**OIL SANDS CO-PRODUCTION EXPERIMENTAL PROJECT
SUPPLEMENTAL INFORMATION REGARDING
AEUB APPLICATION NO. 950993
AEP APPLICATION NO. 001-17233**

OCTOBER 1995

Subject: Application No. 001-17233
THE OIL SANDS CO-PRODUCTION EXPERIMENTAL PROJECT
LEASE 7276120T05

This submission is in response to a September 19, 1995 letter from the Alberta Energy and Utilities Board (AEUB) and a September 20, 1995 letter from Alberta Environmental Protection (AEP) to the SOLV-EX Corporation.

FIGURE QB3.1 CURRENT SURFACE DISTURBANCE AT THE BITUMOUNT
HISTORIC SITE

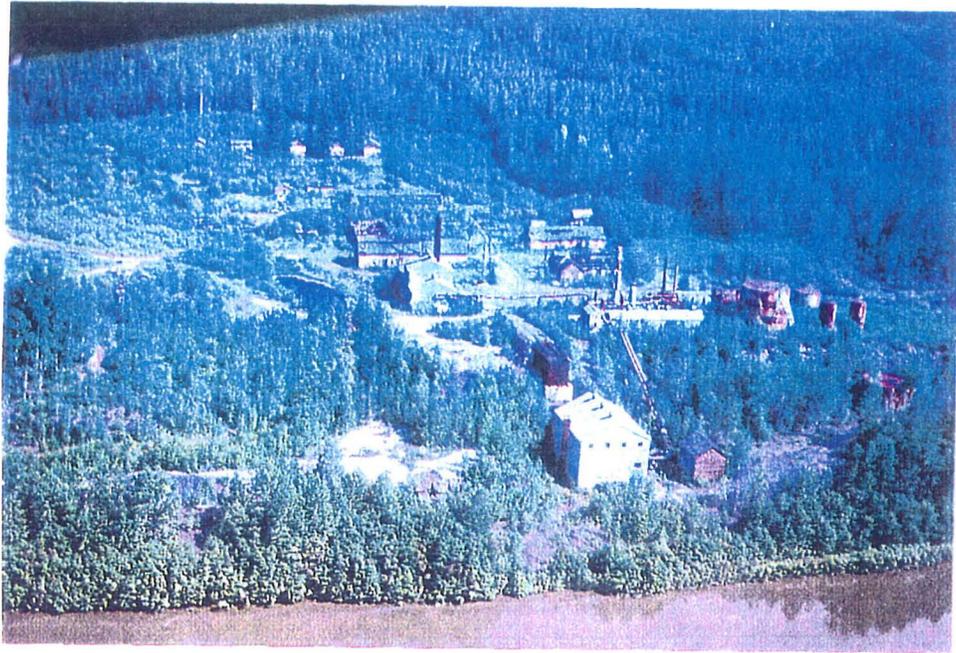
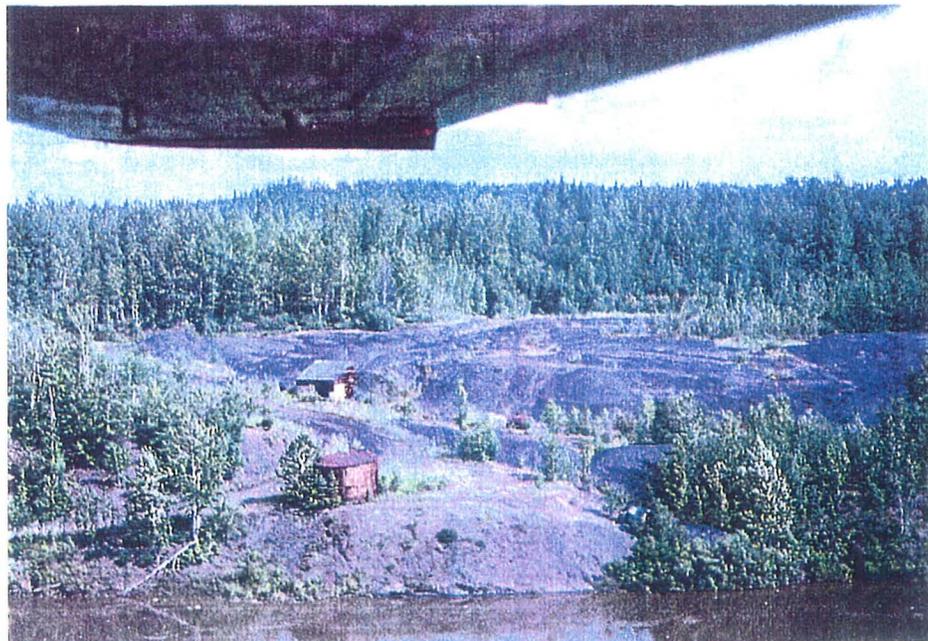
QB3. *Describe the present condition of the proposed development area and the Bitumount historical site. What is it that leads SOLV-EX to think that the visual impact of the proposed facility from the river will be acceptable.*

The current condition of the Bitumount Historic Site is shown by the photos presented in Figures B3.1 and B3.2. Except for the construction of a fence to protect the historic buildings and equipment, the site has not been modified since the pilot extraction facilities were shut down in the mid-1950's. The historic mine area, which lies outside the fence and beyond the area designated as the Historic Site, is poorly reclaimed with unlevel terrain representing piles or windows of oil sand, sparse vegetation on exposed oil sands, and uncontrolled surface runoff containing bitumen and sand. SOLV-EX proposes to excavate overburden and oil sands starting at the previously disturbed mine site, and then reclaim this area to meet current reclamation guidelines by AEP. SOLV-EX further proposes to reclaim that part of the Historical Site that was disturbed through mining and abandoned in the 1950's. SOLV-EX is prepared to discuss with Alberta Community Development the opportunities to further improve the present situation of the Historical Site.

FIGURE QG1.1 WILDLIFE TRAILS

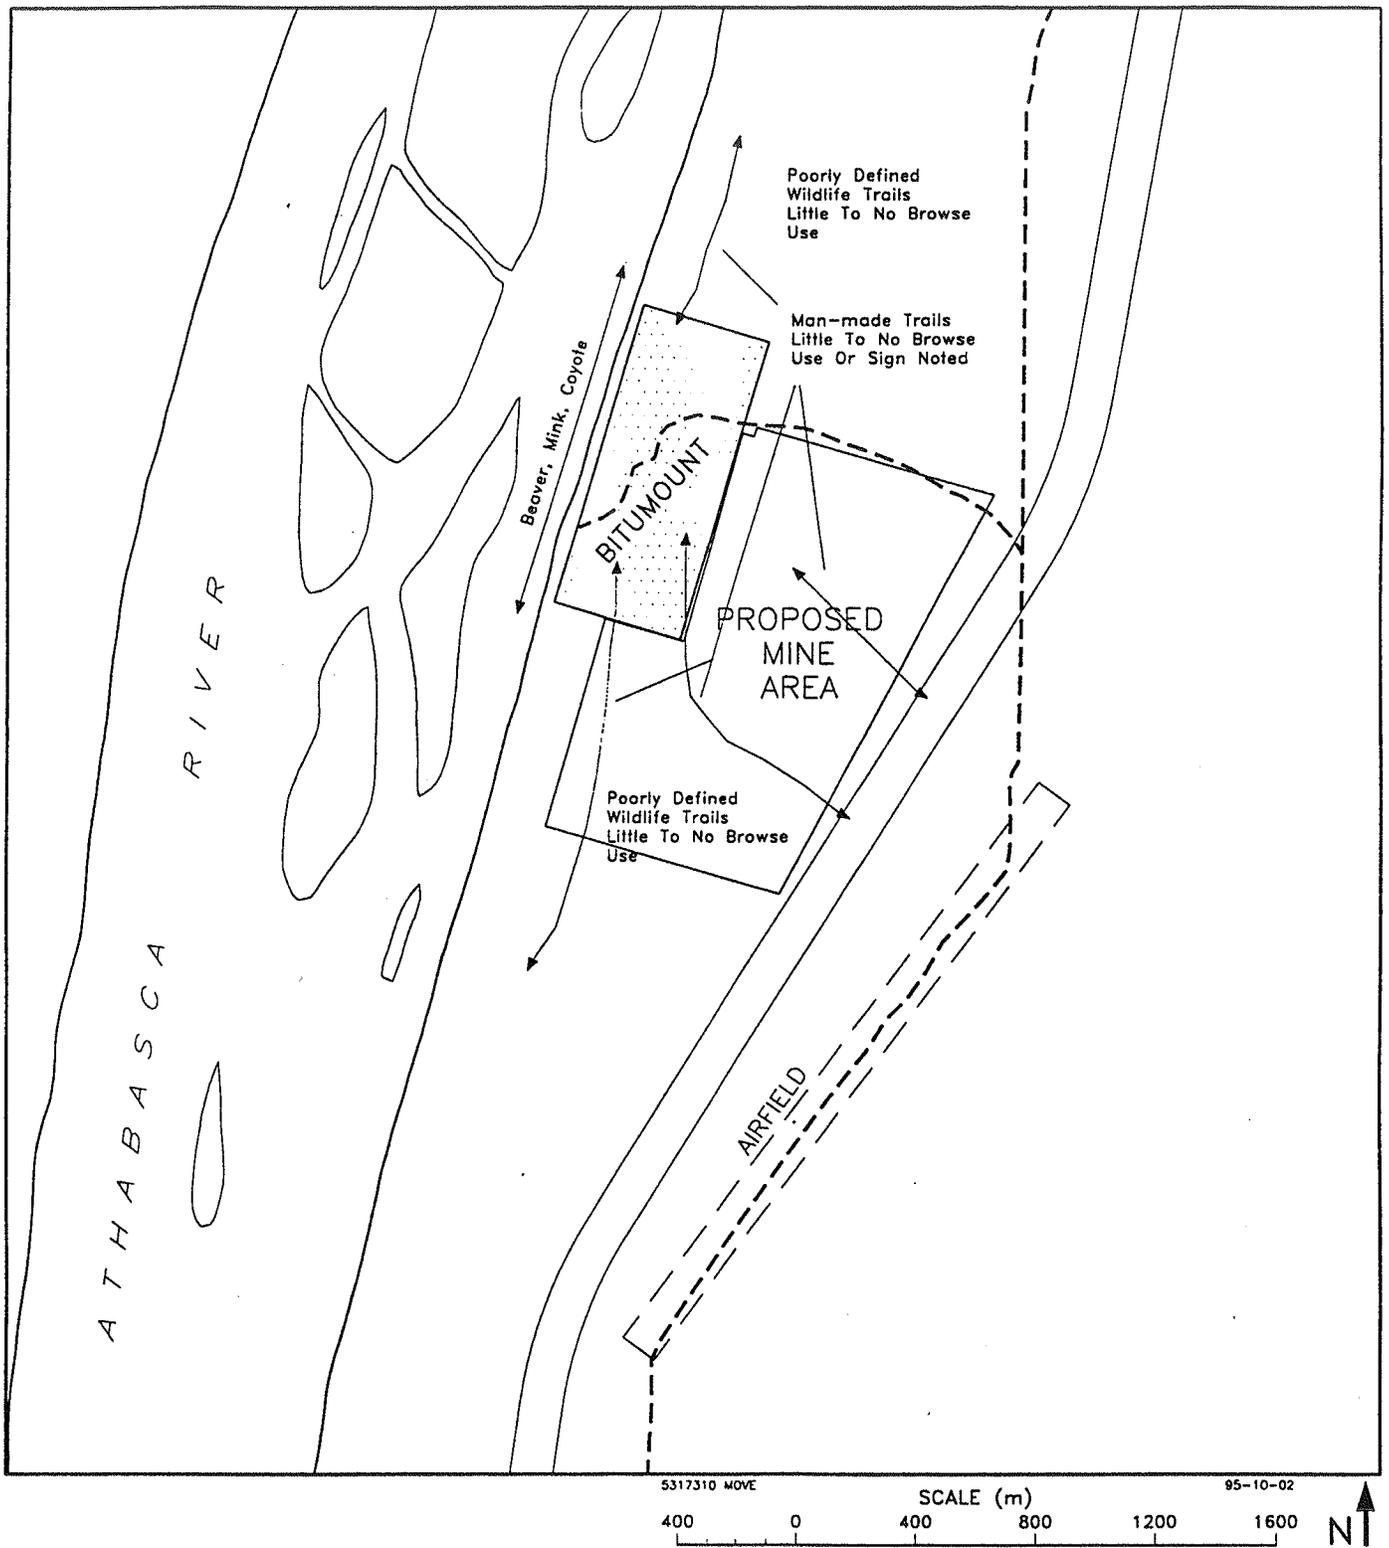
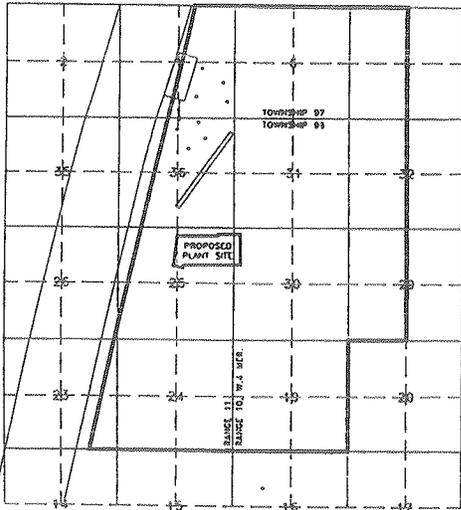
QG1. *The significance of the area as wintering habitat or as a wildlife movement corridor is referred to in various parts of the EIA report, however, the statements should be reviewed with the information obtained this summer. Discuss the importance of the site as a wintering area or movement corridor for wildlife. What species are most likely to be affected and how may their movement patterns change?*

small bench vegetated with alder, red-osier dogwood and poplar, and 100 m from the river is a man-made 3 m wide trail vegetated with grasses or mosses (see Figure QG1.1). However no game trails or signs of browsing/hedging or pellets/scats were evident on the small bench, and the man-made trail did not support any wildlife sign (pellet groups/scats, browse) for several hundred meters. Within the proposed mine area, the newly cleared cutlines and drilling sites (Figure QG1.2) support deer activity (i.e. tracks were observed), which tends to support the hypothesis that the dense vegetation is restricting wildlife movement in the area.

FIGURE 28.2 WASTE WATER MANAGEMENT FOR STREAMS RECYCLED TO PROCESS

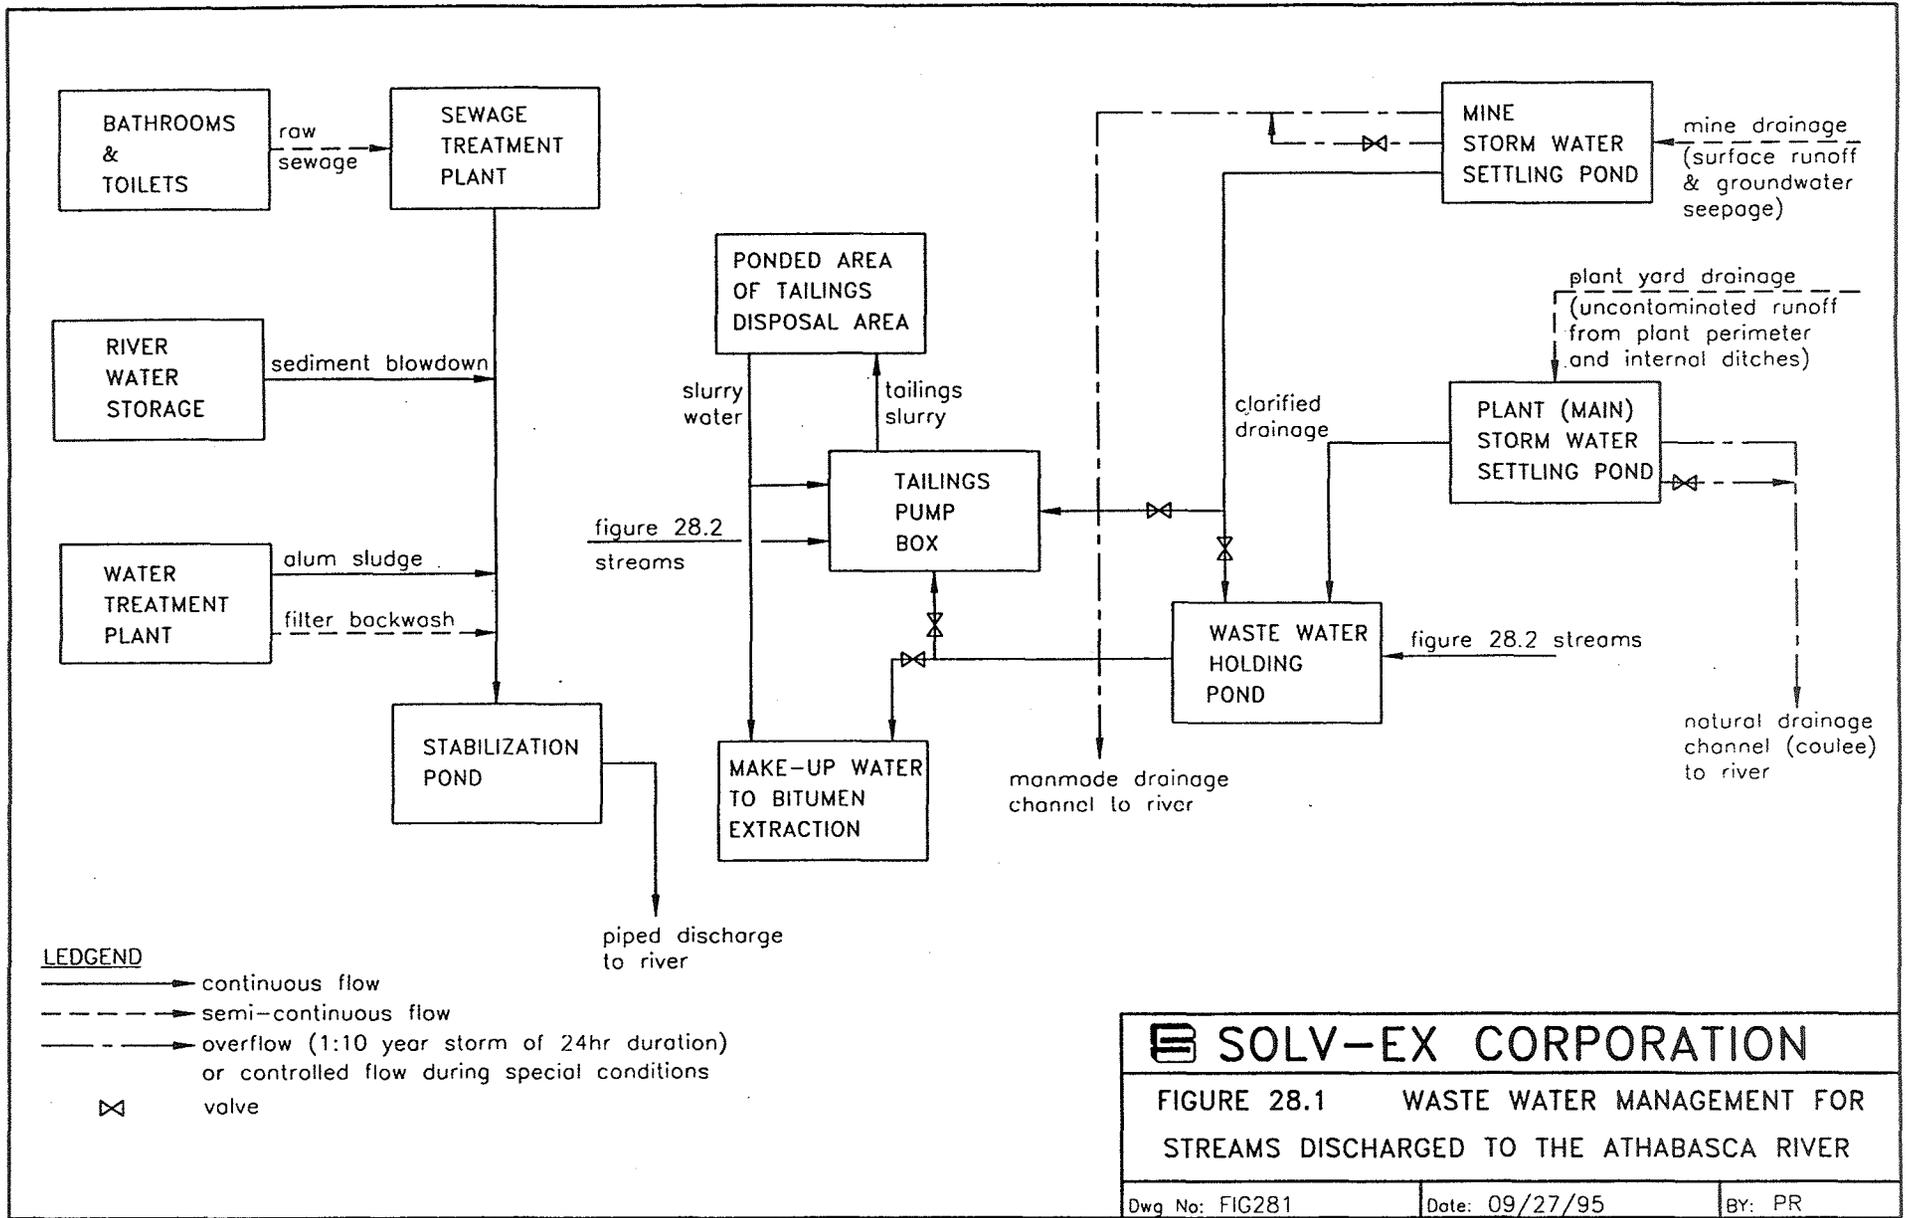
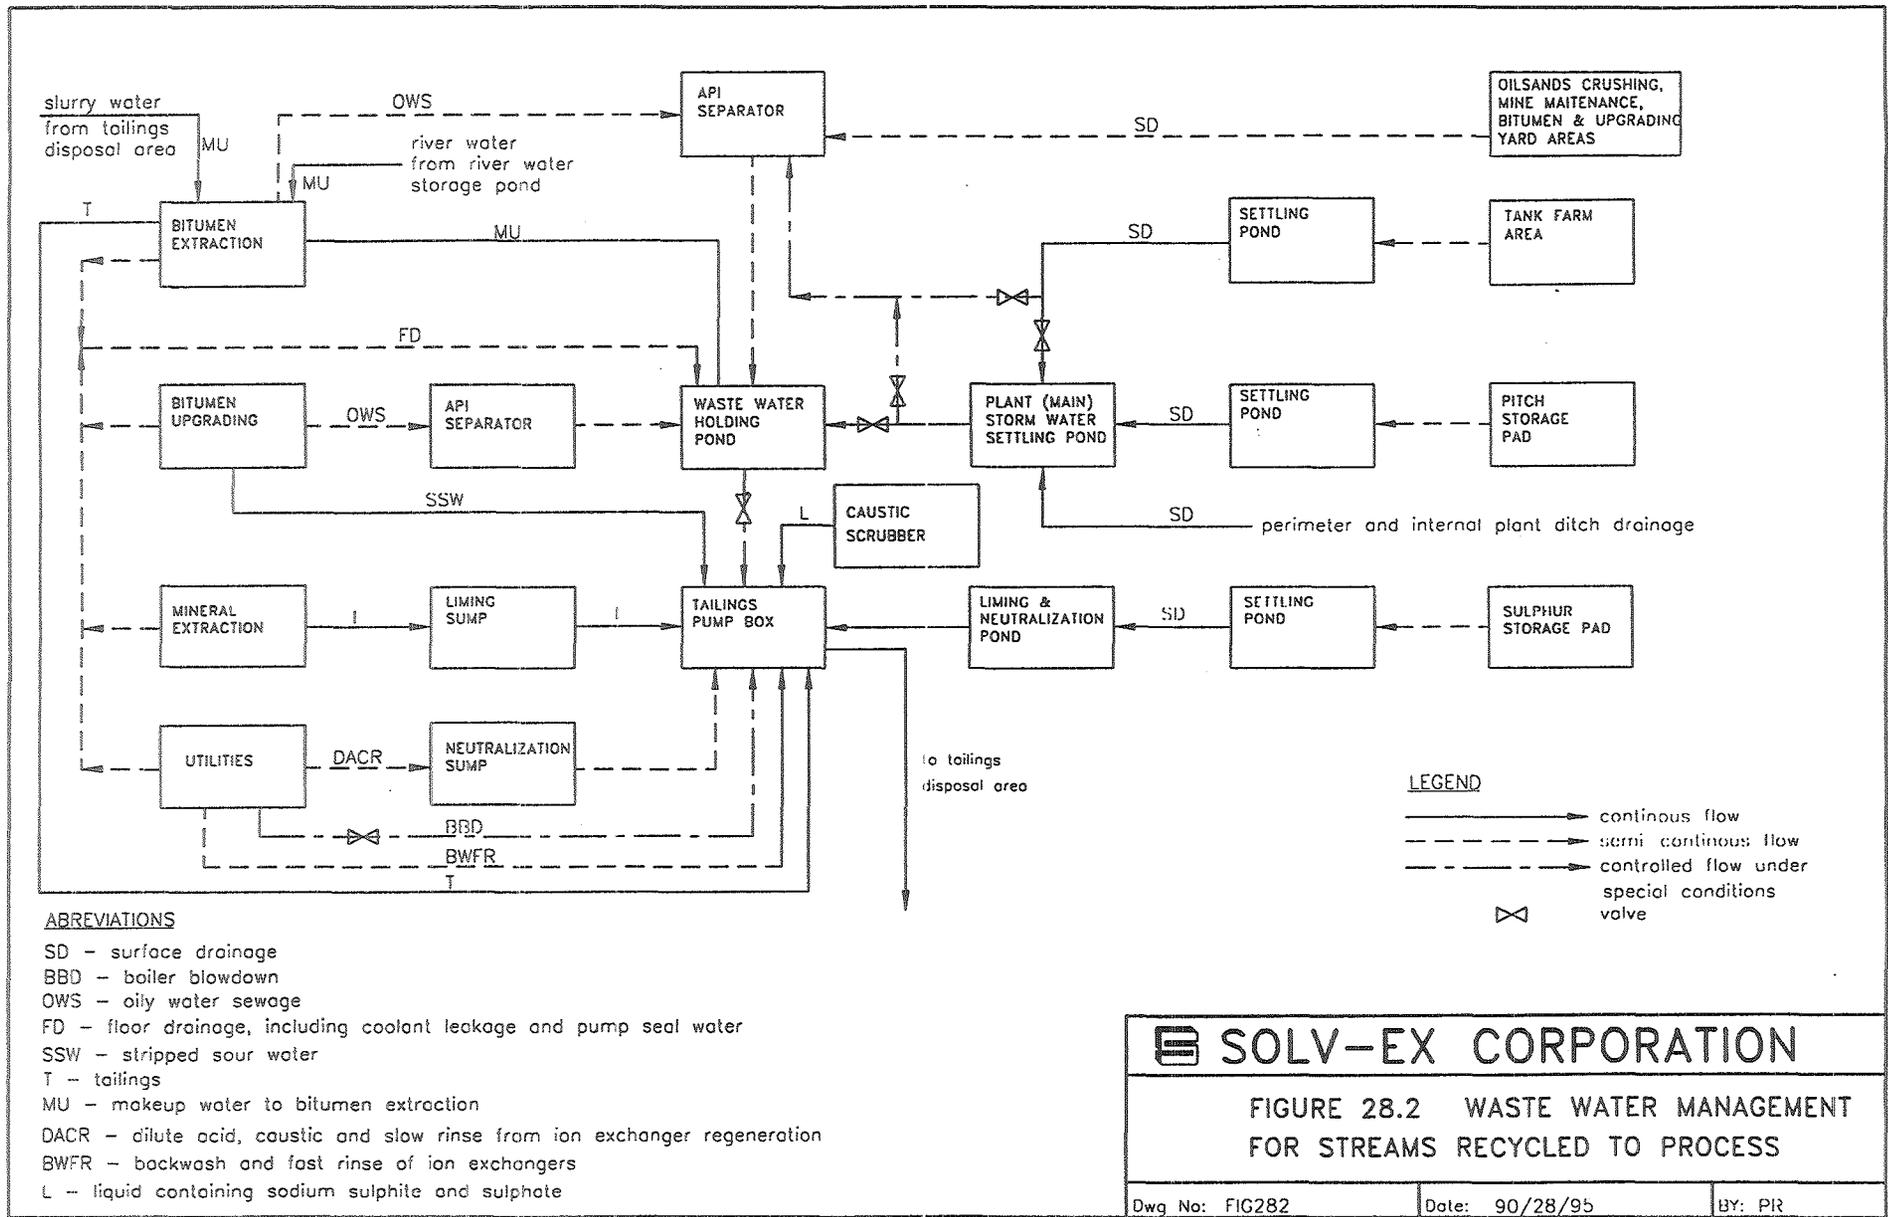
(a) water flows and sources of each input stream,

(b) expected contaminants and their levels of each input stream, and

(c) discharge destination of each pond for each contingency.

Answer: Figures 28.1 and 28.2 show the waste water flow streams and their sources. Estimated flow rates for sewage, alum sludge and filter backwash are documented in Table 4.6 and Figures 4.6 and 4.8 (as regards tailings) of the Application. Estimated flow rates for various other waste water streams are collectively documented in Table 4.4 of the Application.

Answer: Figures 28.1 and 28.2 show the discharge destinations from the various ponds for the following anticipated contingency situations:
